STATE OF KANSAS  
CONSTRUCTION PROJECT NO. A-015174

ADDENDUM NO. 3  
November 15, 2024

Department of Wildlife and Parks  
Kanopolis Visitor Center  
New Construction  
Marquette, Kansas

M101

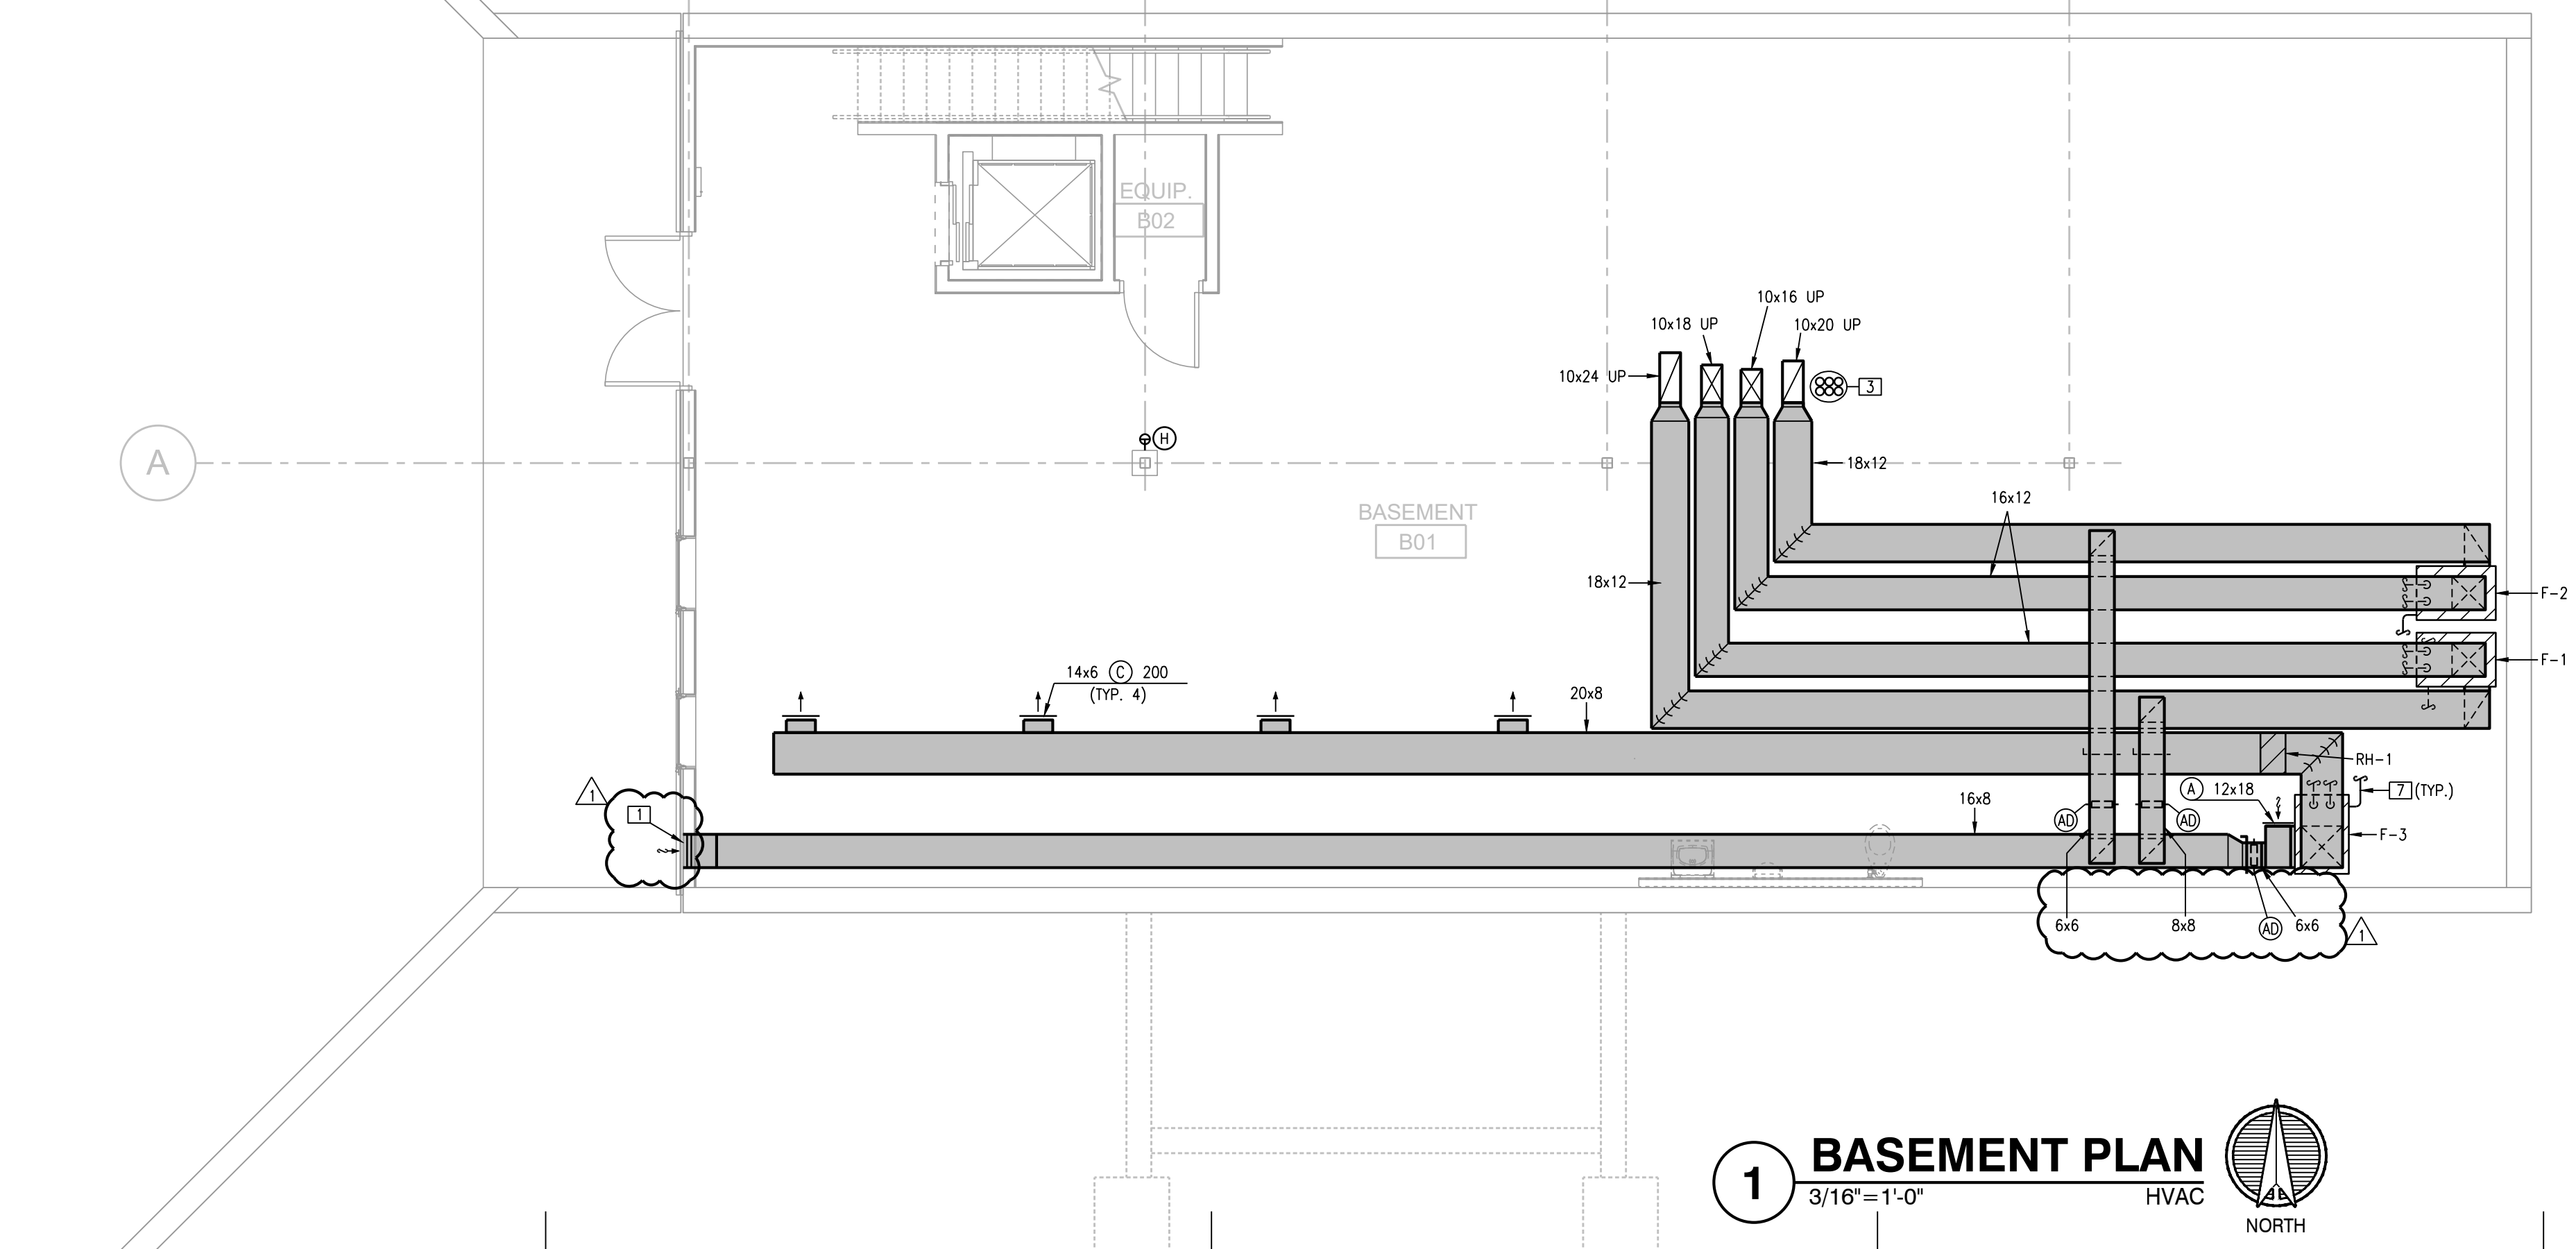
- F. Sheet MP101: Drawing 3 to provide PVC piping in lieu of cast iron piping.
- G. Sheet M101: Added missing duct sizes. **(Attachment)**
- H. Sheet E302: Light Fixture Schedule: Add Fixture type "F1" shall be same fixture as type "F" but provided with emergency battery backup.
